Feedback Form

E2022.010-DVP

Development Variance Permit (DVP) No. E2022.010-DVP

2573 Workman Place (Lot 2, Plan EPP71589, District Lot 207, SDYD)

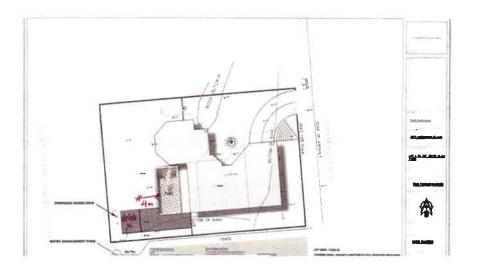
The proposal requests substantial variations to both the required rear-yard and side-yard setbacks.

The design of the home and the location of the pool occupies the buildable footprint, to the full extreme of all the required setbacks, and did not take into consideration that access to their rear yard would be limited, particularly because of the location of the pool.

As a result, the applicant now seeks to remedy their design error by requesting a side yard setback to allow for access around the perimeter of their pool and further extend the proposed deck into the required rear yard significantly. As for the applicants' concern regarding the visual impact of the adjacent public parcel containing the overflow pond, the original design of the house and pool should have taken this into consideration.

As a nearby neighbour, noting that these required rear- and side-yard setback areas generally serve to provide privacy between private and public properties, as well as opportunities for soft landscape areas, they also serve to be part of the visual amenity of the neighbourhood and area. In addition, the requested setback variances for the proposed deck also affect the public views from the KVR pathway by creating a visual impact of overbuilding and oversight from/to the public pathway.

Deck as per application

Reduced depth of deck into rear yard

My suggestion is to minimize the impact on the neighbourhood and public areas, the requested rear yard variance by reducing it to a maximum of 6.5 M allowing for a maximum of 4 M of deck space within the rear yard setback. The lower portion of the deck should be screened and adequate landscaping should be provided between the deck and the remaining rear and side yards.
